# UNITED STATES PATENT AND TRADEMARK OFFICE

# Office Action Summary

10/776,666

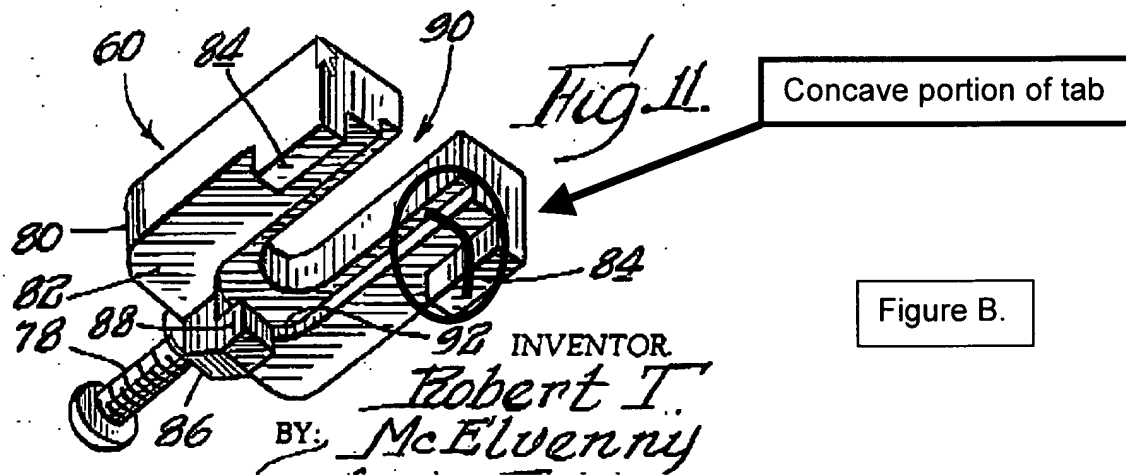
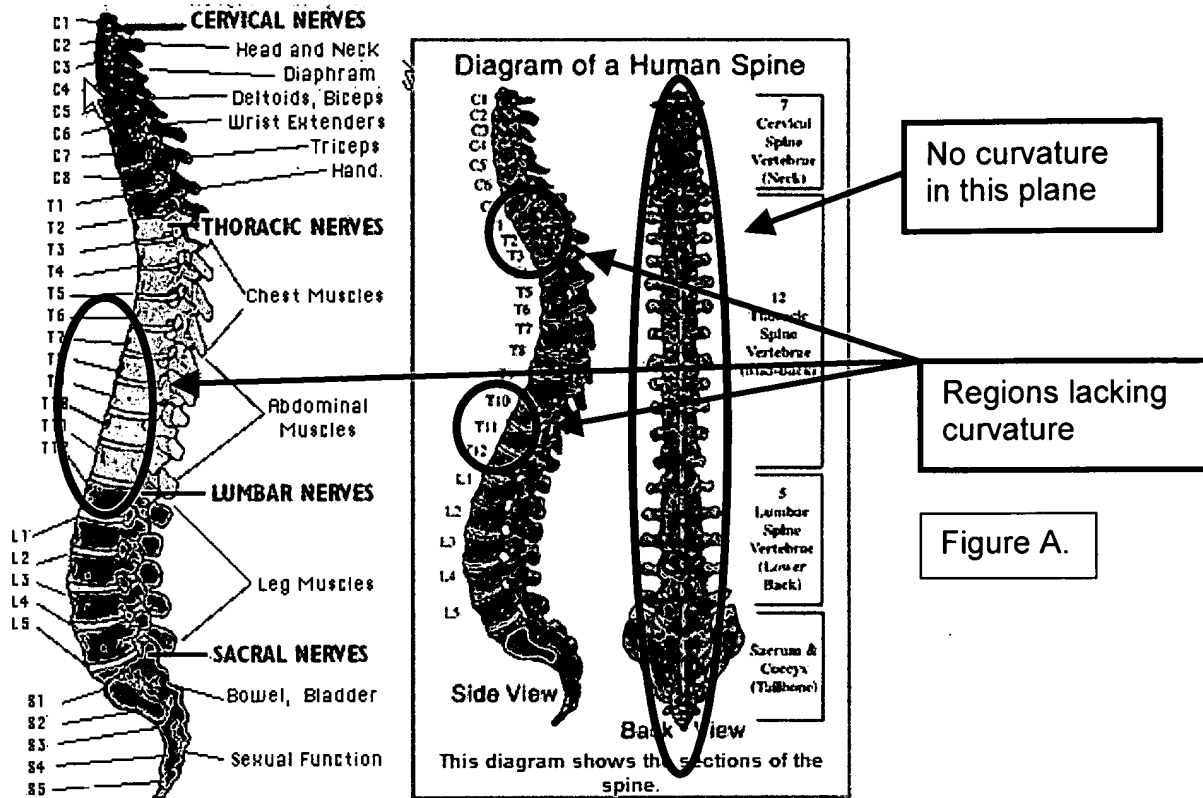
Claims 1-5, 11-13, 15-23, 26, 28, 30, 31, 36-38, 45, 46, 48, 86-93 are rejected under 35 U.S.C. 102(b) as being anticipated by Coates (US Pat# 5423826). Coates discloses an elongate support member, first and second arms (152, 151), transverse to and coupled to the support member at the distal end, both arms being either fixed or slidably movable along the threads on the support member (column 13 lines 58-67) and each arm having a guide member (157) on its proximal end, with two pathways (158) capable of receiving a tool (Figure 16) and for juxtapositioning on a spinal implant (22) such that the bores are aligned (Figure 19) and the plate fits into the groove and hooks of the guide (159/161) which match the contour of the spinal plate. The arms have a distal portion that is at an angle to the proximal portion (Figure 20). Each guide member (157) comprises a housing with opposed first and second pathways (Figure 16) where the housing contains a lumen sleeve (180) which has a rounded tip extends through the barrel into the rounded recess of the accompanying plate. Each pathway in the guide is in communication with each other through the material of the guide and has a cut out portion (159/161) formed in the housing between the first and second pathways (Figure 16) where the cut out portion extends from the housing where the pathways (158) are in

communication through the body of the guide. In one embodiment of the guide the bores are in communication through the overlap (121, Figure 11). The c-shaped hooks (161) extend from the distal end of the guide member and are opposed tabs which are opposed to the spinal plate (22) and have the bores (158) between them where the tabs have a shape adapted to match the contour of the plate and fit into the slot of the plate on the perimeter of the plate. The support member (155) has adjustment knob (154), which allows either arm to move along the adjustment threads of the lockable support member (column 13 lines 50-67). Please note the intended use, as set forth in the claims, carries no weight in the absence of any distinguishing structure.
